Re: Project No./Docket No. 35077—Wind Energy Transmission Texas, LLC’s Generation Interconnection Agreement Filing Pursuant to PUCT Substantive Rule 25.195(e)

**FIRST AMENDMENT TO
GENERATION INTERCONNECTION AGREEMENT**

Exhibit "C"
Interconnection Details

Attachment 1 to Exhibit "C"
One Line Diagram

DRAWING TITLE
SUBSTATION SINGLE LINE - 1 (ALT)

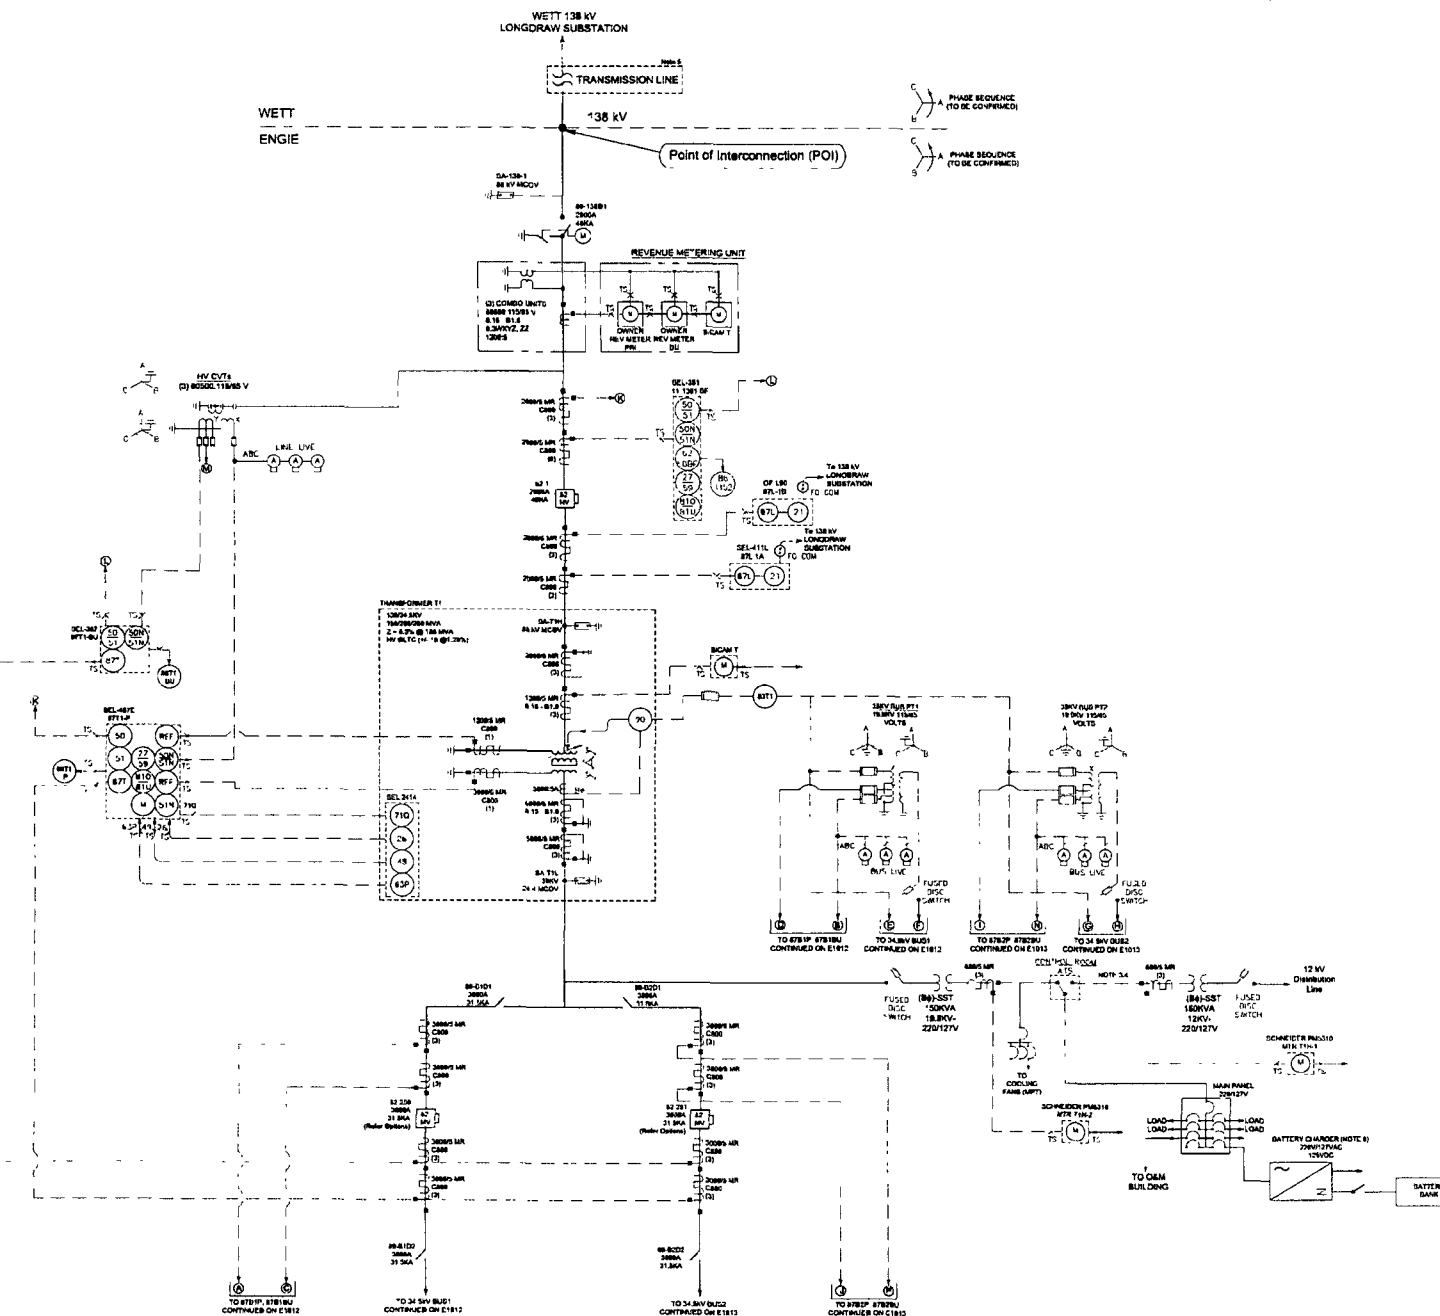
1. All capitalized terms used herein and not otherwise defined have the same meaning as those used in the Original GIA.
2. Exhibit "C" Interconnection Details of the Original GIA is hereby replaced in its entirety with the Exhibit "C" Interconnection Details attached to this Amendment including Generator's substation single line diagram attached as Exhibit C-1.
